COASTAL & HEARTLAND NATIONAL ESTUARY PARTNERSHIP
1050 Loveland Blvd., Port Charlotte, FL 33980
941/833-6580
www.CHNEP.org

Subject: CHNEP's Technical Comments to Proposed USGS Major Update to Region 03 – FL Hydrologic Units

CHNEP Recommendations for Proposed Major Update to Region 03 – FL Hydrologic Units

Option 1 – More Conservative Proposed HUC Change

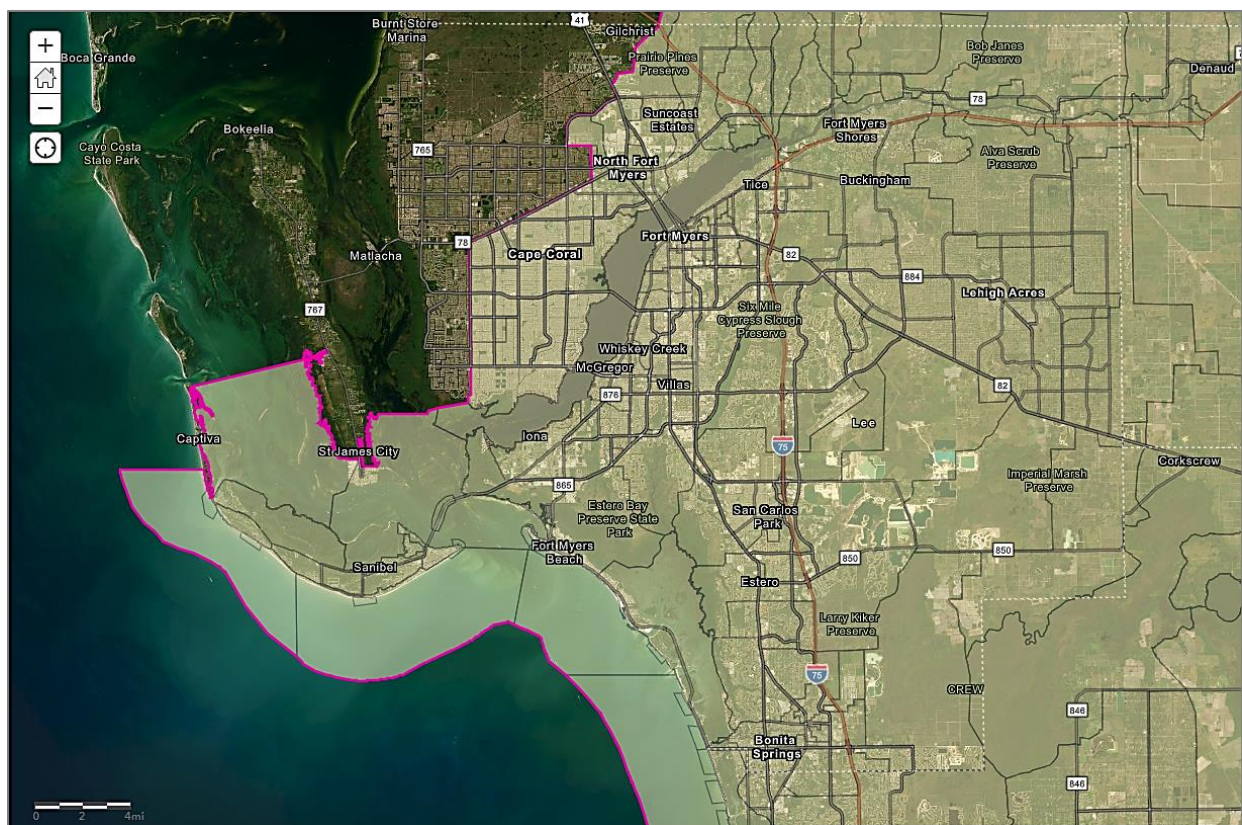
The CHNEP proposes to expand HUC 0309 further west to include the Caloosahatchee River impacts on Sanibel and San Carlos Bay, with the cut off between HUCs 0309 and 0310 being Redfish Pass. This proposed change would align with Waterbody ID (WBID) boundaries and is illustrated in the map provided below. With this proposed change, HUCs 0309 and 0310 would be more representative of the majority influence of the major rivers they encompass. Circulation maps demonstrating that HUC 0309 Caloosahatchee River flows primarily into San Carlos Bay, while HUC 0310 Myakka and Peace Rivers flow primarily into Charlotte Harbor are provided below. This option is the minimum refinement we would suggest, to more accurately depict the flow and circulation of these two systems where they meet.

Option 2 – More Expansive Proposed HUC Change

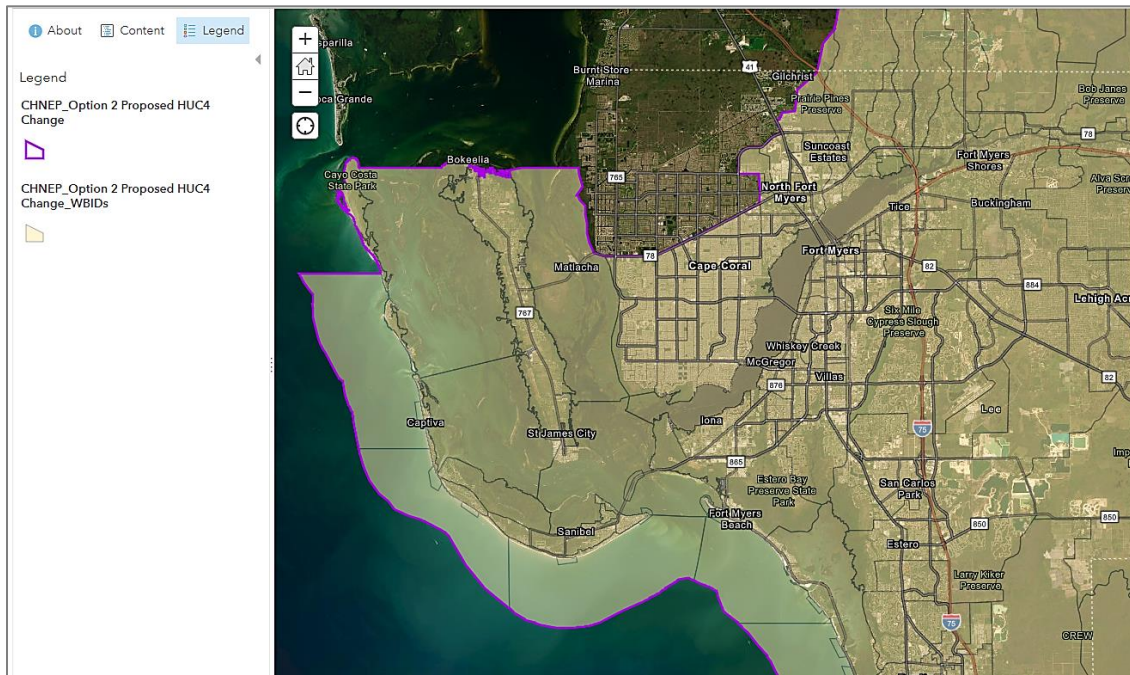
The second option would be to expand HUC 0309 further west to include the Caloosahatchee River impacts on Pine Island Sound and Matlacha Pass and Pine Island Sound, with the cut off between HUCs 0309 and 0310 being Boca Grande Pass. With this proposed change, HUCs 0309 and 0310 would be more representative of the majority influence of the major rivers they encompass when the circulation patterns of the Caloosahatchee are more expansive reaching near the top of Pine Island (and even sometimes into Lower Charlotte Harbor), as demonstrated in the Circulation and Hydrodynamic Modeling Map below. This proposed change would align with WBID boundaries, and the Caloosahatchee River Watershed Protection Plan Caloosahatchee Basin Map (Source: South Florida Water Management District) as is illustrated below.

West Florida Coastal Ocean Model (WFCOM) Circulation Map showing more circulation

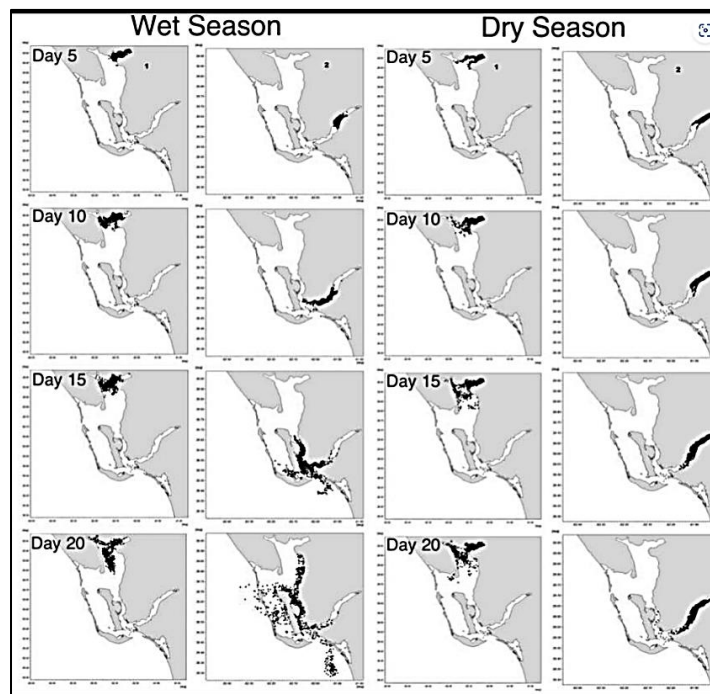
Hydrodynamic Model Maps from [Circulation dynamics and seasonal variability for the Charlotte Harbor estuary, Southwest Florida coast](#) by B Dye, F Jose, MN Allahdadi - Journal of Coastal Research, 2020 showing the results of a particle transport study on Peace River and Caloosahatchee River under contrasting hydrologic conditions. Panels on the left represent Peace River simulations; panels on the right represent Caloosahatchee River simulations, divided by dry and wet seasons. You can see that Caloosahatchee Estuary particles move out through San Carlos Bay but also up into Matlacha Pass and Pine Island Sound (and sometimes along the east wall of Charlotte Harbor) at certain times of year.

Current Region 03 – FL Hydrologic Units and WBIDs

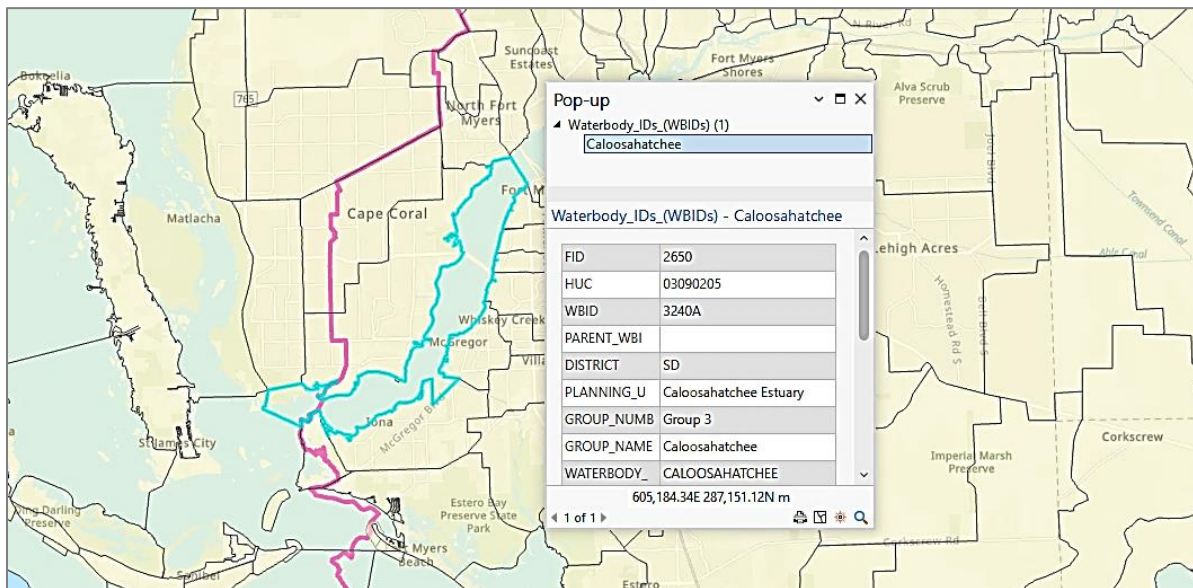
Another important issue to note is that the Hydrologic Units do not currently align with WBID boundaries, including several WBIDs that overlap HUCs 0309 and 0310 as shown in the map image below. These include, but are not limited to, WBIDs 2065H1, 3240A, 3240A1, 3240A2, 3240L, 3240O, 3240F, 3240T, 3240EB, and 8059. CHNEP recommends HUCs to be aligned to WBIDs, with HUCs being updated as WBIDs are adjusted over time. Both recommended options outlined above would help fix this issue by aligning HUCs 0309 and 0310 with the Run 64 WBID boundaries.
